Re: Petition No. 1575: Salisbury Substation Transformer Replacement Project

Response to CSC-01 Interrogatories dated June 20, 2023

Set 01 – Questions 1-23

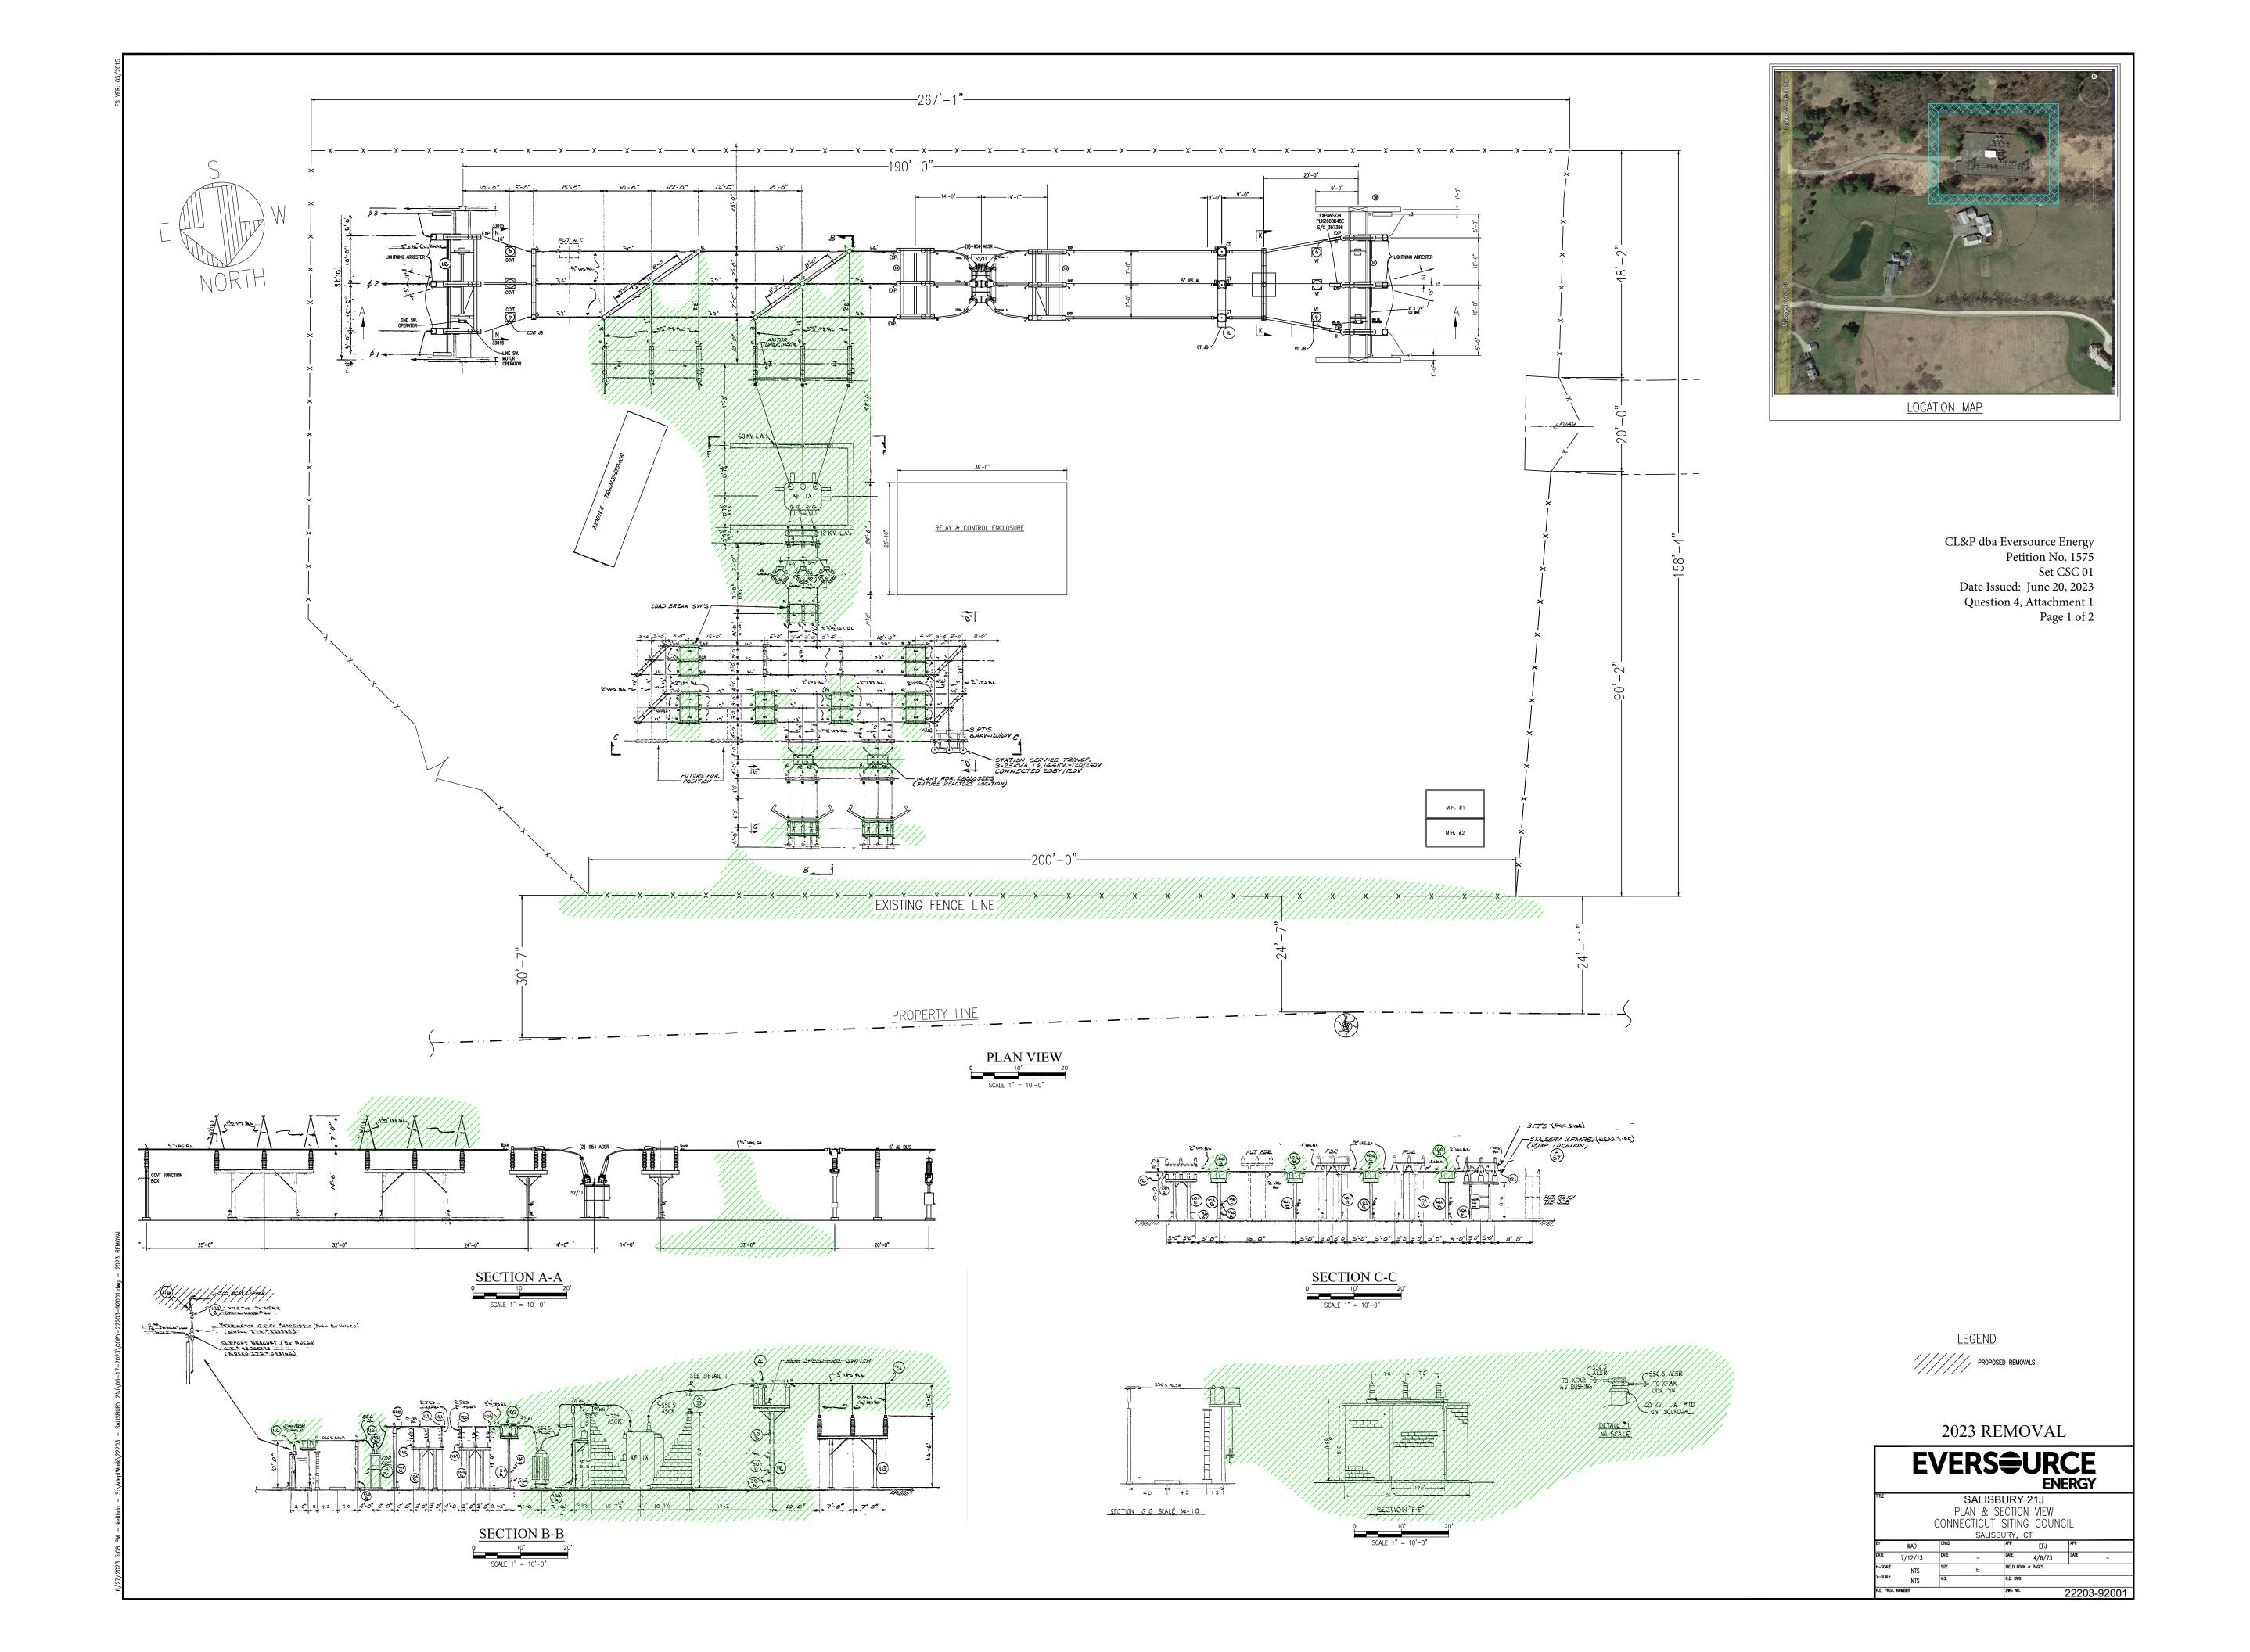
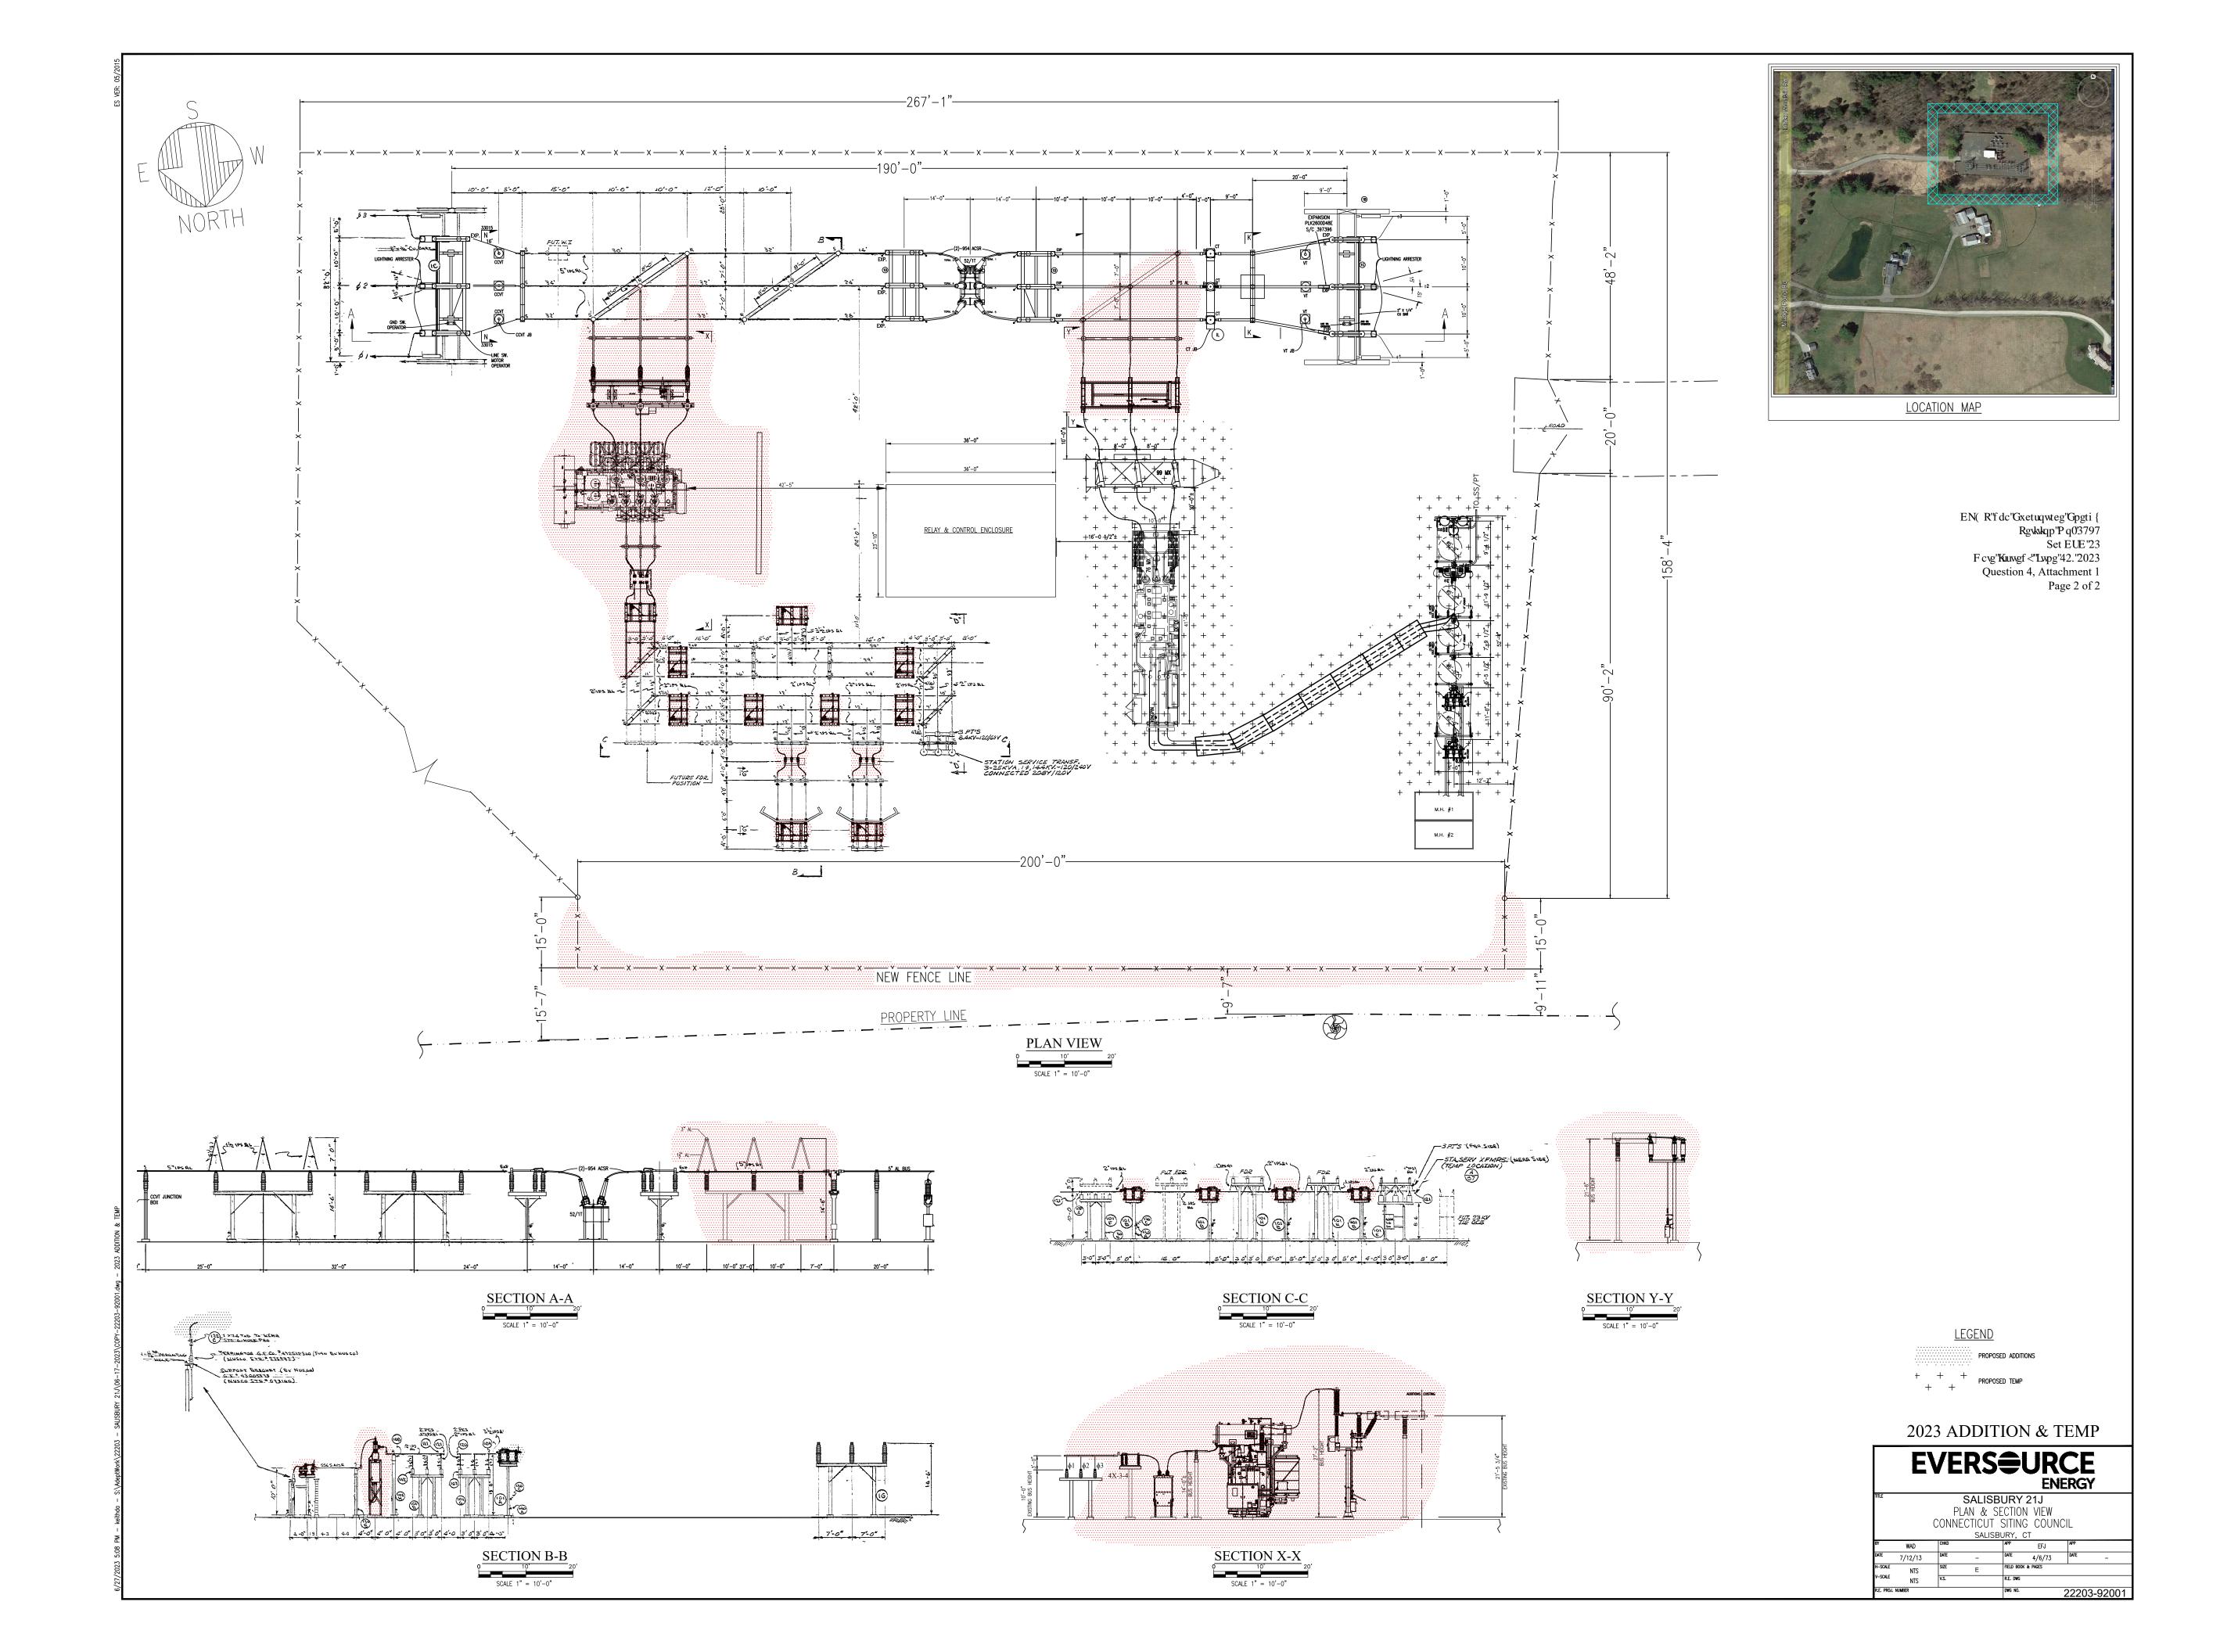
Provide a drawing with distances from the proposed expanded substation facility to abutting property lines.

Attachment 4.1 includes two drawings – the first drawing illustrates the distance from the existing substation fence to the northern property boundary, while the second drawing depicts the distance from the proposed expanded substation fence to the northern property boundary. For this Project, the substation fenced area will only be expanded to the north; as a result, there will be no change in the distance from the substation fence to properties that abut the Company property on the east, south, or west.

As illustrated on the Attachment 4.1 drawings, the substation's existing northern fence is not uniformly aligned parallel to the property boundary. As a result, as summarized in the table below, after the proposed expansion of the substation and the relocation of its northern fence by 15 feet to the north, the distances from the substation fence to the abutting property boundary also will vary from west to east.

Fence	Distance from Northern Substation Fence to Abutting Property Line (				
	Northwest Fence Corner	North-Central Fence	Eastern Fence		
Existing Fence	24 feet11 inches	24 feet7 inches	30 feet7 inches		
Proposed Expanded Fence	9 feet11 inches	9 feet7 inches	15 feet7 inches
